ADDENDUM - 01

DATE:Monday, 20 March 2023

RYEB Project #5718A
Salem City BOE
SALEM HIGH SCHOOL STADIUM
NJDOE SP#: 4630-050-23-1000

SALEM CITY SCHOOL DISTRICT
HOME & VISITOR BLEACHERS
SALEM, NEW JERSEY

1. OWNER/OWNERS REP SHALL VERIFY ALL DIMENSIONS PRIOR TO START OF CONSTRUCTION.
2. REINFORCING STEEL SHALL BE ASTM GRADE 60.
3. CONCRETE SHALL HAVE A MINIMUM COMPRESSIVE STRENGTH OF 4,000 PSI AT 28 DAYS.

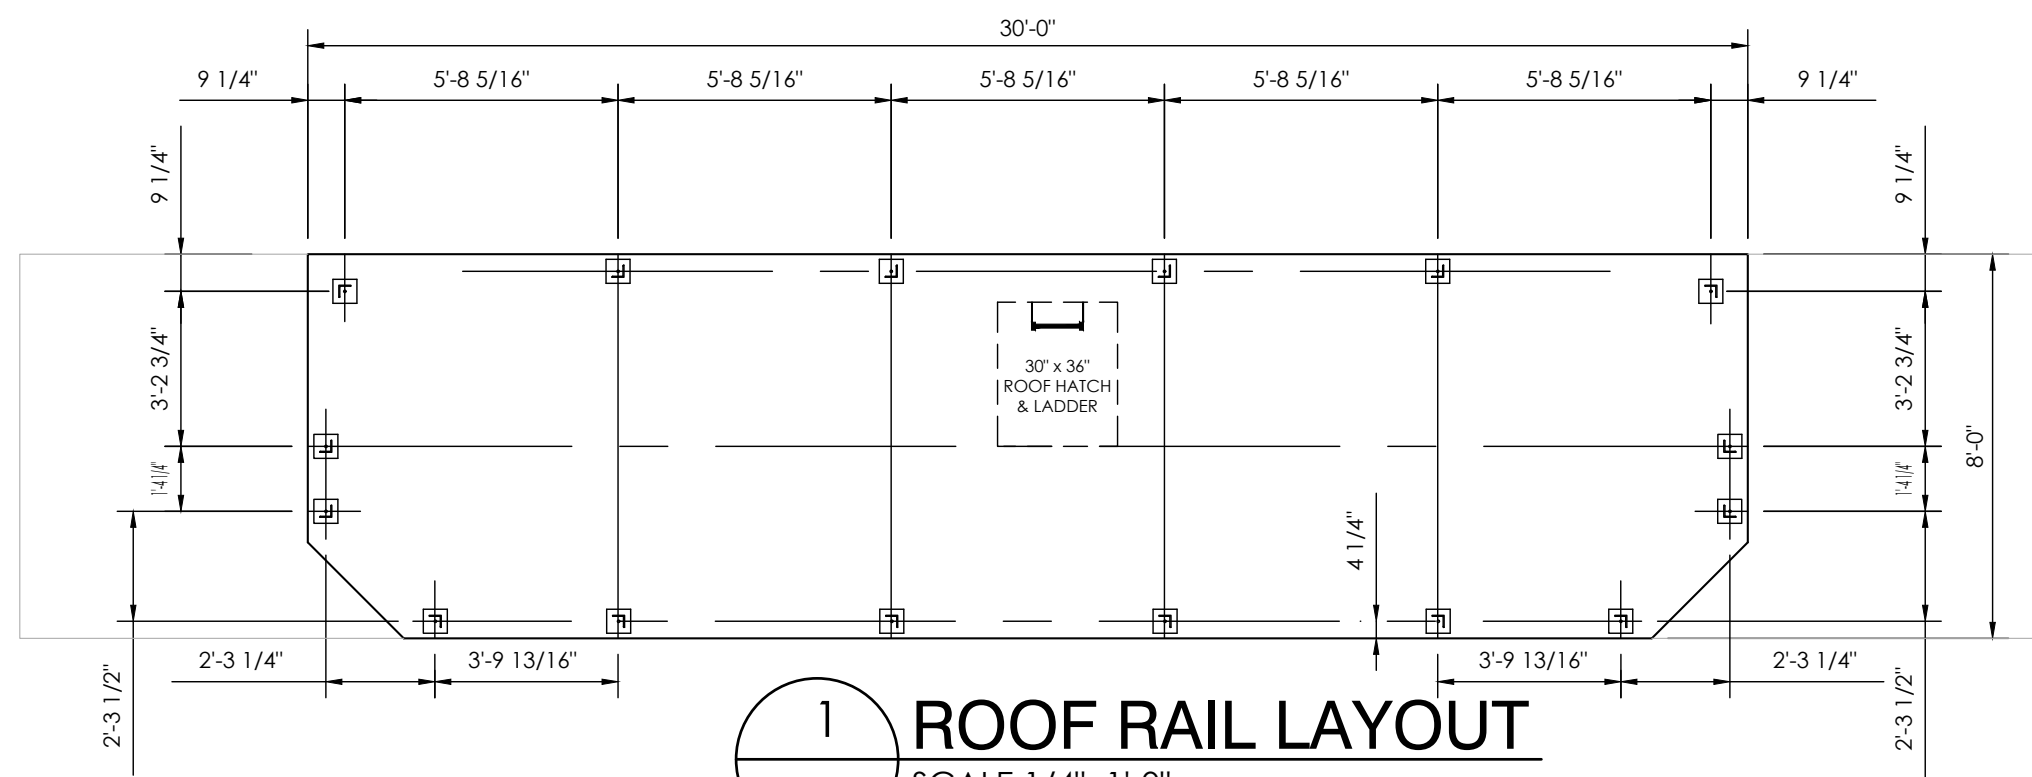
2. Concrete foundations shall be installed below frost level.
